ALERT SERVICE BULLETIN
Bell Helicopter **TEXTRON**

NO. 205B-05-44

SUBJECT: TAIL ROTOR BLADE P/N 212-010-750-009 THROUGH -129, INSPECTION AND REWORK OF.

Figure 1: Inspection and Rework Area

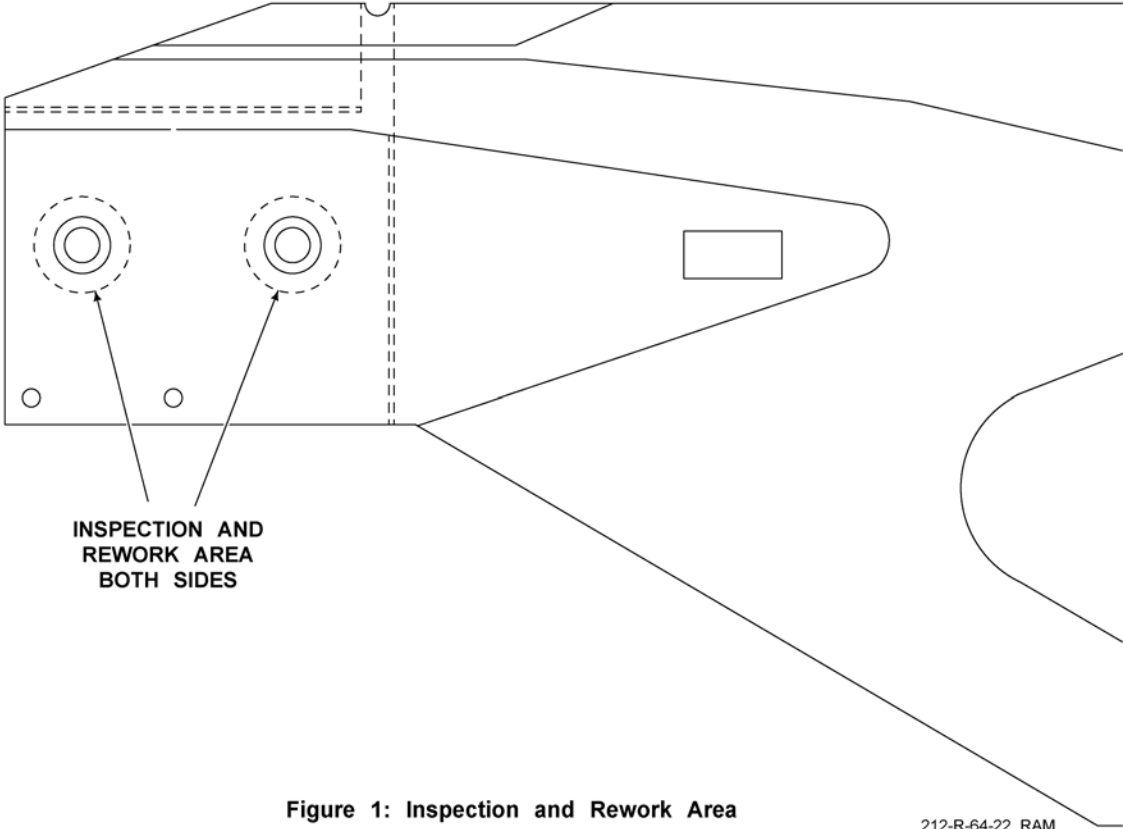
2. Remove paint and adhesive filler in blade bolt washer contact area per Figure 1 using plastic media blasting per the BHT-ALL-SPM.
3. Inspect reworked surface for damage and corrosion. If corrosion is found or damage beyond manual limits, send blade to Bell approved repair facility for repair.
4. Measure depth of spotface on reworked surfaces at all four locations. If depth exceeds 0.035 inches remove blade from service.
5. Apply by brush cleaner (C-344) to the bare metal surface of the reworked area.
6. Thoroughly rinse with water and dry surfaces with a clean dry rag or filtered compressed air.
7. Apply chemical film (C-100) to reworked area.
8. If buffers are damaged, replace per applicable section of CR&O.
9. Refinish blade per CR&O.
10. Install tail rotor blade on aircraft and dynamic balance.
11. Annotate records to indicate compliance with Part II of this bulletin.

Alternate paint and adhesive removal may be accomplished by using a 180 grit cloth or paper and sanding by hand in a spanwise direction only. Surface finish of 32 RMS or better must be accomplished in the rework area after removal of adhesive using 400 grit cloth or paper. Do not remove more than .001" of aluminum material.
